## **Acet 22220 (2 Wire) NEW 2011 VERSION**

(AC BUZZER HAS BEEN REPLACED WITH ELECTRONIC CALL TONES)

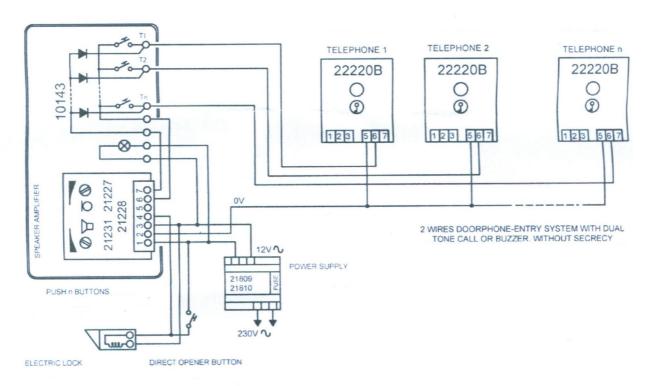
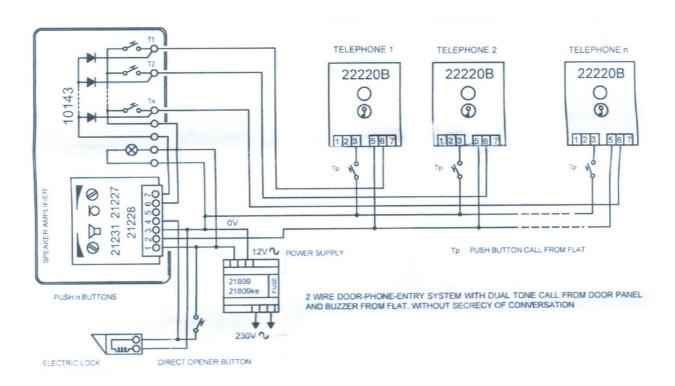
Note: There are 2 versions of this handset, they look exactly the same externally. NEW VERSION (2011) Mechanical buzzer is replaced by electronic call, wiring exactly the same as before.
